SECTION 96 SUBMISSION

DEE WHY RSL CLUB - 932 PITTWATER ROAD
STAGE 5 CLUB EXTENSION

THIS PLAN TO BE READ IN CONJUNCTION WITH
MOD2018/0119
NORTHERN BEACHES COUNCIL

PROJECT:
STAGE 5 - CLUB EXTENSION
PHASE 2 WORKS - SOUTHERN
CARPARK & ENCLOSURE

3 5-EX-SHADOW DIAGRAM - 3PM 21JUNE-NE
Scale: 1 : 1000

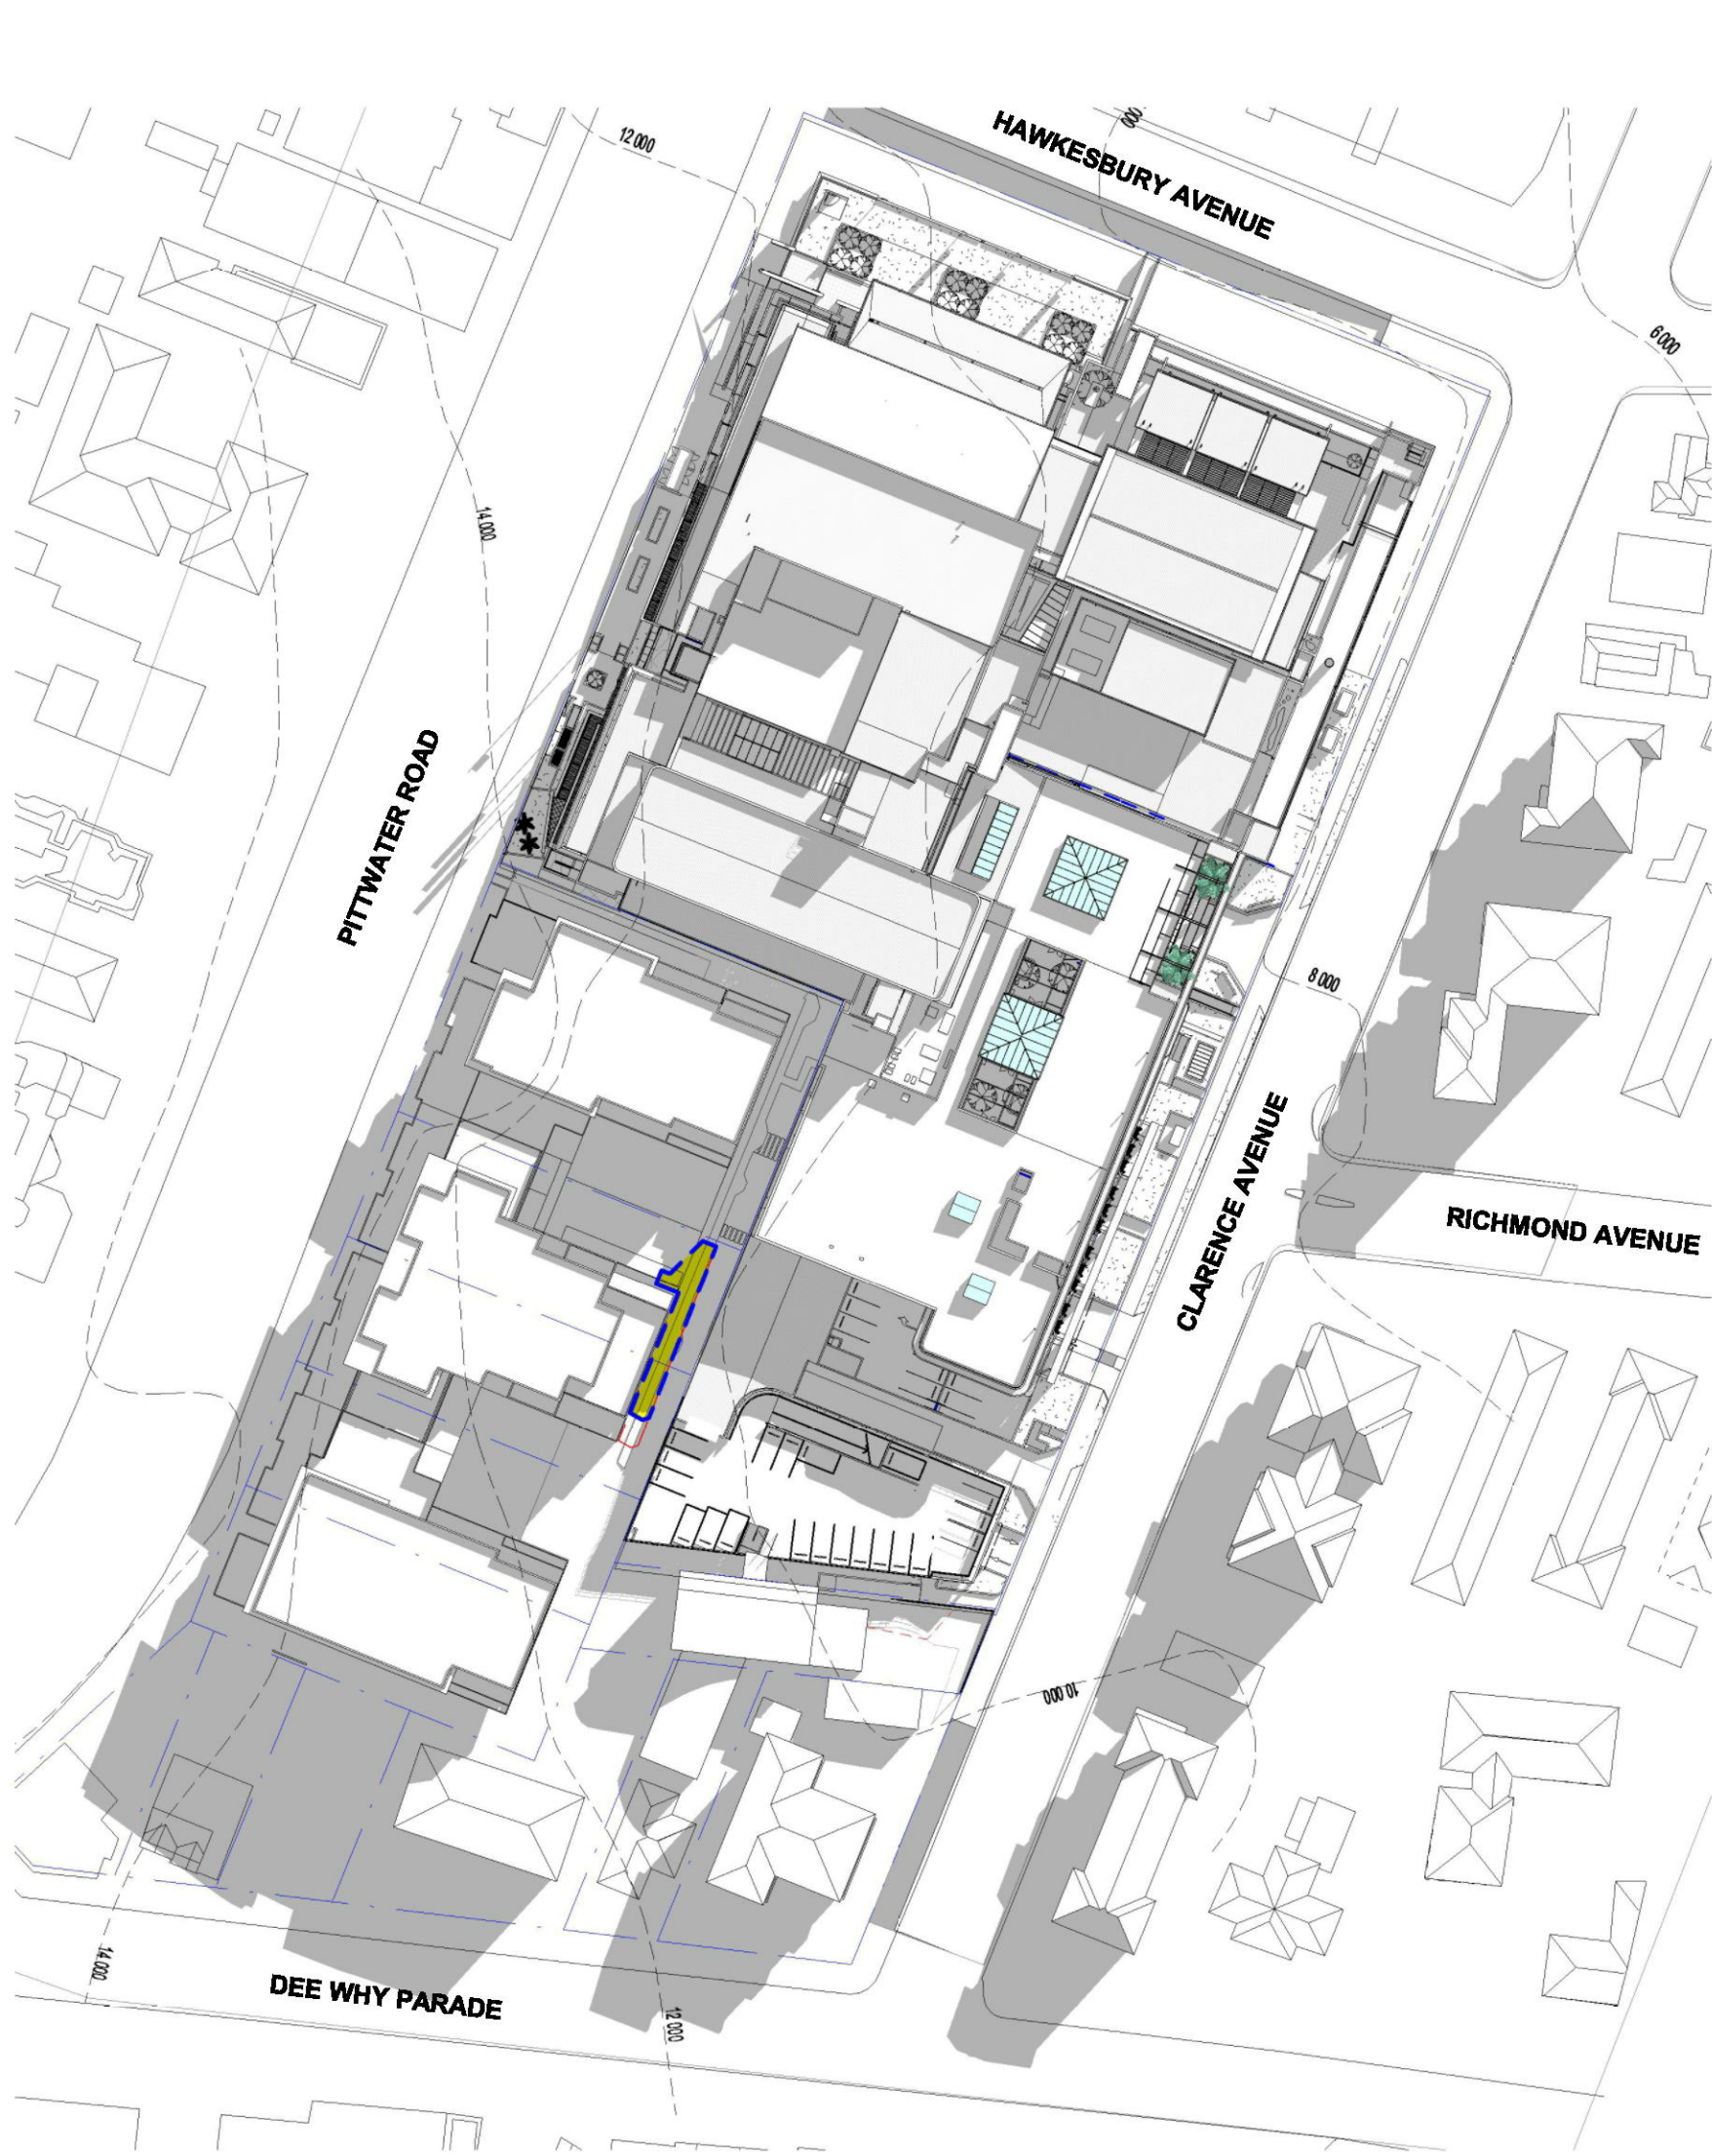
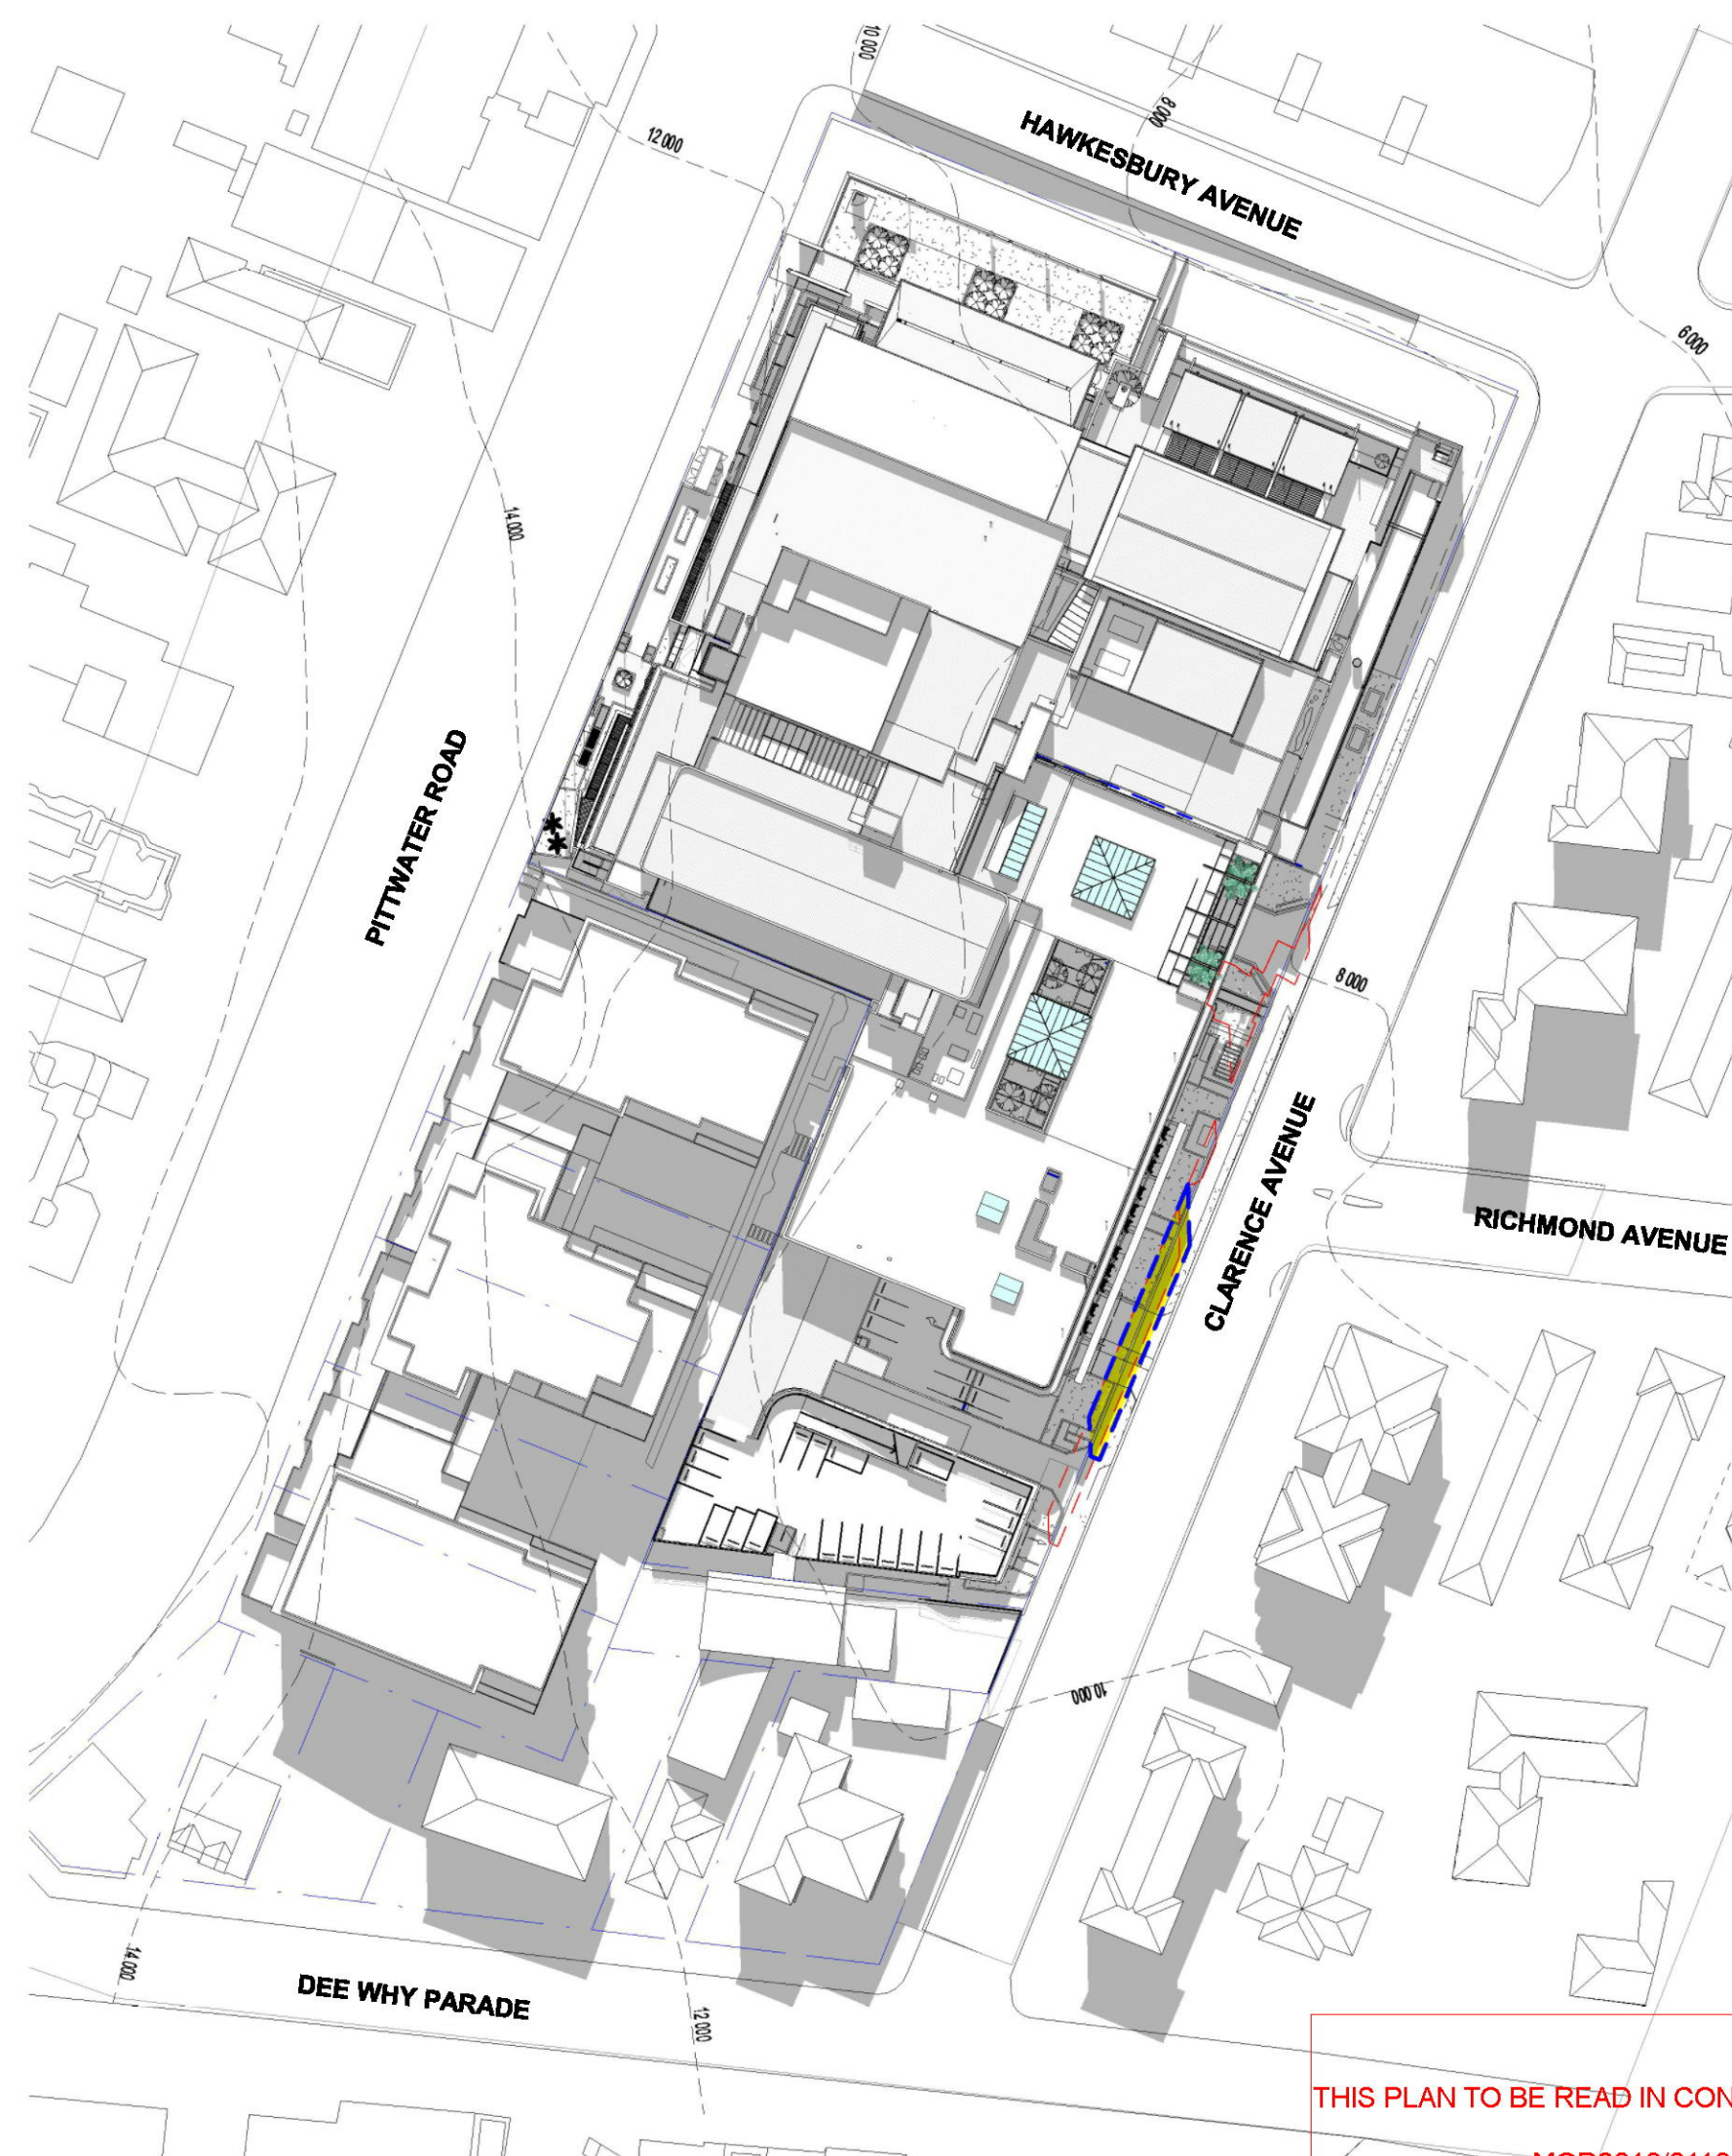
- SHADOW CAST BASED ON SECTION 96 MODIFICATIONS, REDUCED IMPACT
- SHADOW CAST ONTO SURROUNDING BY PROPOSED DEVELOPMENT AS PER ORIGINAL DA 2017/0244
